This document created by the Florida Department of Business and Professional Regulation -

TAC: Plumbing

P10323]			1
Date Submitted	02/12/2022	Section	454.1.2.1	Proponent	Dallas Thiesen
Chapter	4	Affects HVHZ	No	Attachments	s Yes
TAC Recommendation	Approved as	Submitted			
Commission Action	Pending Revi	ew			
<u>Comments</u>					
General Comments	Yes	Alternate La	anguage `	Yes	
Related Modifications	S

P10211					3
Date Submitted	02/11/2022	Section	403.6	Proponent	Dallas Thiesen
Chapter	4	Affects HVHZ	No	Attachments	Yes
TAC Recommendation	Approved as	Submitted			
Commission Action	Pending Rev	iew			
<u>Comments</u>					
General Comments	Yes	Alternate La	anguage	Yes	
Related Modifications	5

TABLE 403.6 PUBLIC SWIMMING POOL—REQUIRED FIXTURES COUNT <u>PER SQUARE FOOT OF POOL</u> <u>SURFACE</u>

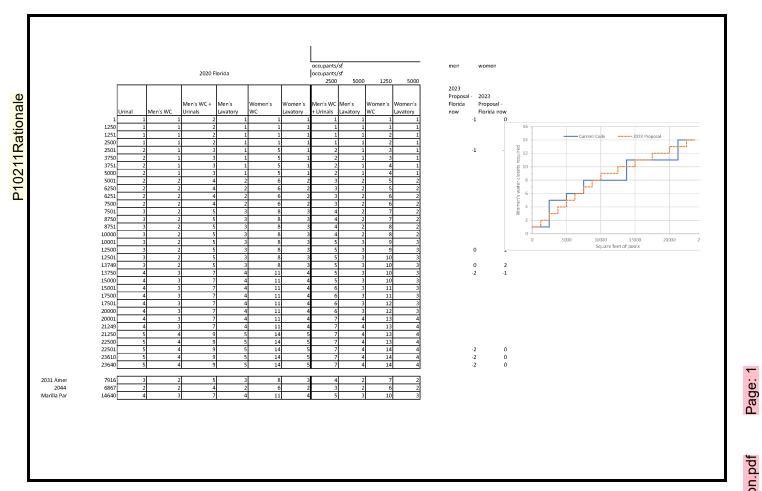
Simples required sanitary fixture calculations and creates a more gradual increase in required fixtures as the swimming pool size increases.

Reference to unisex restrooms is outdated; single user restrooms are already allowed to contribute to minimum fixture requirements per 403.1.2 of this Code. For all other restrooms, urinals are optional per 424.2 of this Code, that should apply to outdoor pools as well. Reference to bathing load is confusing, requires separate calculation. The thresholds here are harsh. There is no reason that going from 2,500 to 2,501 square feet should cause four additional women's water closets to be required. Each threshold should be a single fixture.

403.6 Sanitary facilities for public swimming pools. Swimming pools with a bathing load of 20 persons or less may utilize a unisex restroom. Pools with bathing loads of 40 persons or less may utilize two unisex restrooms or meet the requirement of Table 403.6. Unisex rRestrooms shall meet all the requirements for materials, drainage and signage as indicated in Sections 454.1.6.1.1 through 454.1.6.1.4 of the Florida Building Code, Building. Each shall include a water closet, a diaper change table, a urinal, and a lavatory. Diaper changing Tables are not required at restrooms where all pools served are restricted to adult use only. Pools with a bathing load larger than 40 persons shall provide separate sanitary facilities labeled for each sex. The entry doors of all restrooms shall be located within a 200-foot (60 960 mm) walking distance of the nearest water's edge of each pool served by the facilities.

Fixtures shall be provided as indicated on Table 403.6. The fixture count of Table 403.6 is deemed to be adequate for the pool and pool deck area that is up to three times the area of the pool surface provided. An additional set of fixtures shall be provided in the men's restroom for every 7,500 square feet or major fraction thereof for pools greater than 10,000 square feet. Women's restrooms shall have a ratio of three to two water closets provided for women as the combined total of water closets and urinals provided for men. Lavatory counts shall be equal.
